INDESIT company

Model type:
IDL50EU

Commercial code:
F030217

Notices

N1045072FIG1

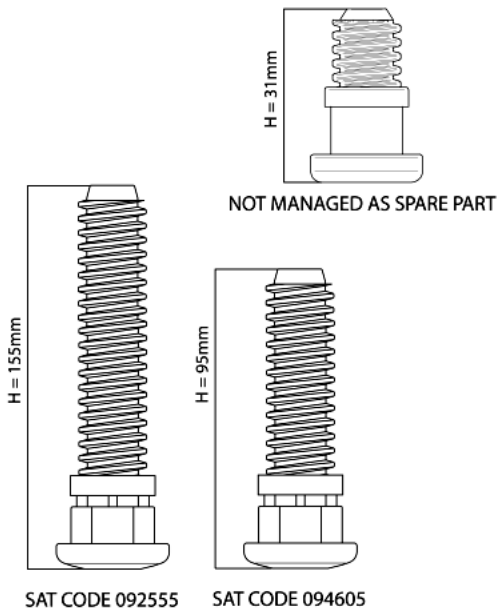
N1045072: Introduction of fixed rear foot H=31mm on free-standing models.

From serial no. 40218.0001, free-standing dishwashers affected by this modification have been equipped with new fixed rear feet (H=31mm).
The new foot replaces the adjustable one (H=155mm) Service code 092555; on the EVO3 range with TurboDry the new foot replaces the adjustable foot (H=95mm) Service code 094605.
The Spare Part Warehouse will continue to manage only 155mm and 95mm adjustable feet as they are interchangeable with the fixed 31mm foot.
The three feet are shown in illustration N1045072FIG1.

n1045069: Modification of racks and dispenser lid on EVO3 dishwashers

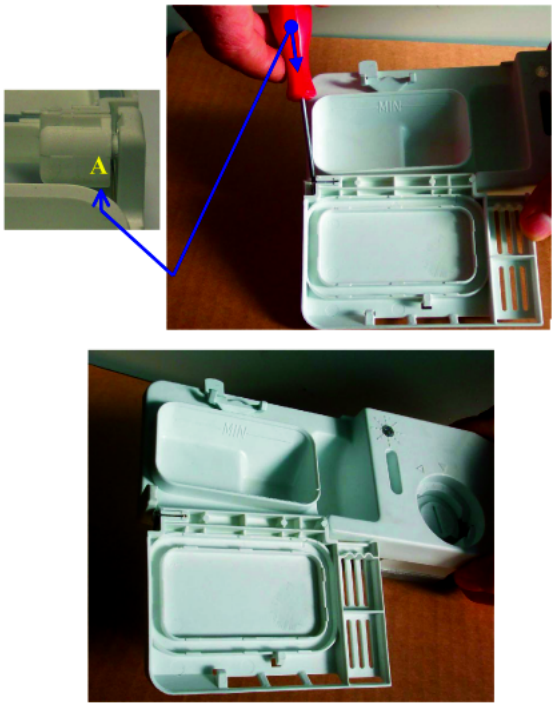
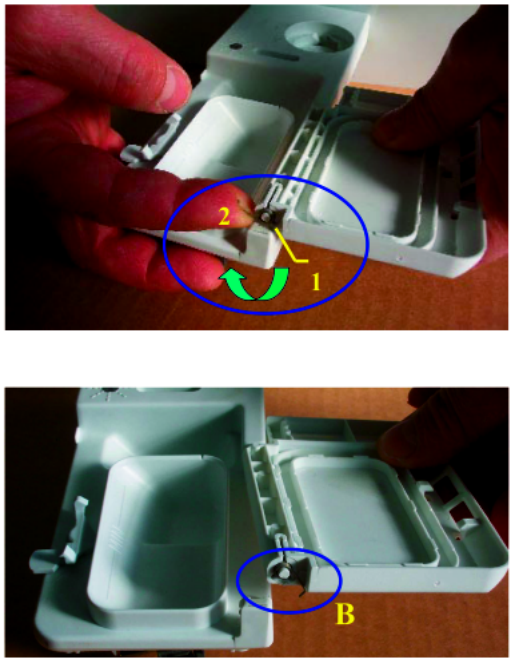
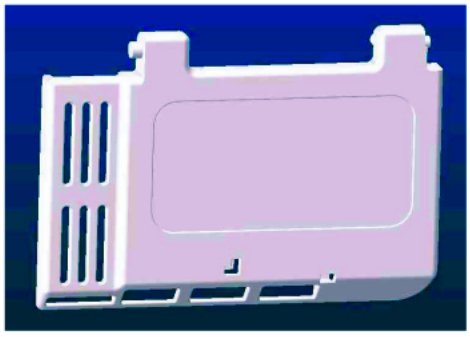
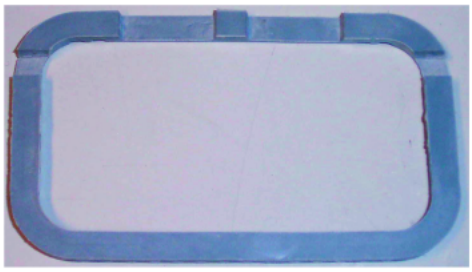
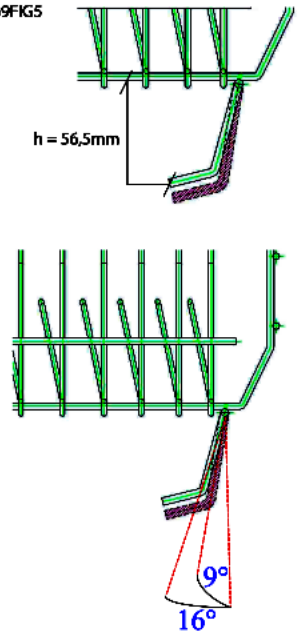
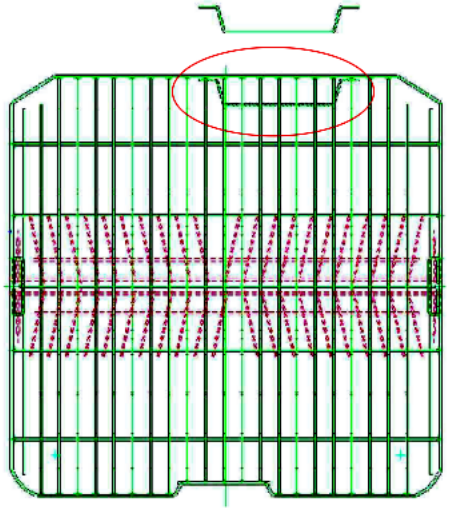
To obtain better dissolving of the detergent during the wash cycle, the following modifications have been made to EVO3 dishwashers:
- new dispenser lid, replacement code 098134 (see figure N1045069FIG4) created;
- upper racks modified with lid catch angle changed from 9° to 16° (see figure N1045069FIG5);
- MultiSystem lower racks modified with insertion of a spacer wire at the electric dispenser (see figure N1045069FIG6).

The upper and lower racks have the same spare part codes as the premodification items; Replacements Warehouse stocks have been replaced.

Lid installation instructions:
1) prise the lid out of the dispenser seat using a small screwdriver at point A (figure N1045069FIG1);
2) replace the lid, checking that release spring B (figure N1045069FIG2) is in place; before fitting the new lid load the spring from position 1 to position 2 (figure N1045069FIG2);
3) fit the lid in its special seat and check for correct operation (figure N1045069FIG3).
Lid closing may be harder for the first few cycles after replacement, due to settling of the material.

N1045080FIG1

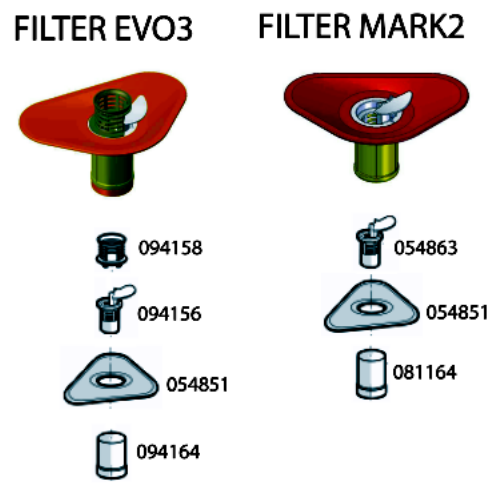
n1045080: Modification of front feet on free-standing DW.

From serial no. 40413.0001, free-standing dishwashers affected by this modification have been equipped with new front feet Service code 109991 in place of 056414.
The new foot is shown in fig. N1045080FIG1.

n1045085: Introduction of new litre counter turbine integrated on air-break.

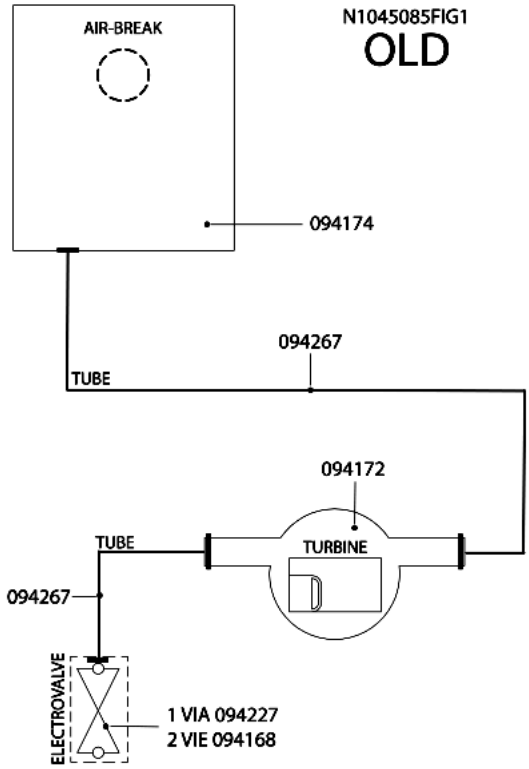
All dishwashers affected by this note have been equipped with a new litre counter turbine on the air-break.
Picture N1045085FIG1 illustrates the premodification structure, picture N1045085FIG2 the new structure.

AIR-BREAK:
new 110610;
premodification 094174;
the new item features a new integrated litre counter turbine and its water supply hose has a smaller diameter.

LITRE COUNTER TURBINE code 094172 has been eliminated.

SOLENOID VALVES:
new:
1-WAY code 110611;
2-WAY code 084558(Rohs 143737);
premodification:
1-WAY code 094227;
2-WAY code 094168;
the new solenoid valves have a smaller diameter drain hose fitting.

HOSES:
new solenoid valve hose/air-break code 110612;
premodification turbine hose/air-break code 094267;
premodification solenoid valve hose/air-break code 094267;
the new hose has a smaller internal diameter.

WIRING:
the litre counter turbine connecting cable is longer, but since the connector is the same, the new item can be used in place of the premodification one.

n1045127: New airbreak - solution of water spurts leaking from base LVS 60 CM

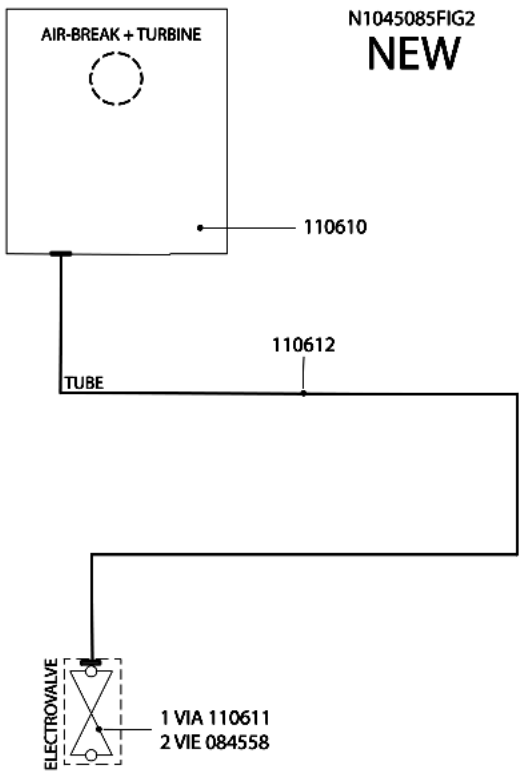
From serial number 50930.0001, to solve the problem of water spurts emitted from the lower right and left side of the door the following modifications were introduced in production:

1-Airbreak without insert to allow the necessary pressure venting
2-Honeycomb top panel to protect the kitchen unit from any steam emitted (only on built-under models)
3-Tank seal length increased by 3 cm to improve water tightness
4-Die-cut roof sound-deadening panel
5-Three clips for correct fixing of the tank base seal (in production from serial number 50701.0001)

New parts:
C00141308 - Airbreak
C00141310 - Honeycomb top panel (built-under versions only)
C00141317 - Tank seal
C00141314 - Roof sound-deadening panel
C00140679 - Tank base seal fixing clip

Premodification parts
C00110610 - Airbreak
C00116110 - Tank seal
C00097300 - Roof sound-deadening panel

1) AIRBREAK REPLACEMENT
It is mandatory to use the new part; in the event of replacement with premodification appliances proceed as follows:
- replace the airbreak with the new part C00141308
- if present, refit the roof sound-deadening panel after cutting out a 10x10 cm square from the rear left-hand corner
- on the built-under version, fit honeycomb panel C00141310 on the top of the appliance
- replace tank seal with the new seal P/N C00141317

WARNING: when replacing an airbreak without a litre-counter turbine use exclusively the same type of part (P/N C00094174 - all the relevant details are given in bulletin n1045085)

2) CHANGING THE TANK SEAL
On appliances with serial number from 40101.0001 to 50930.0001, you can use the new tank seal P/N C00141317 after cutting 1.5 cm off each end.
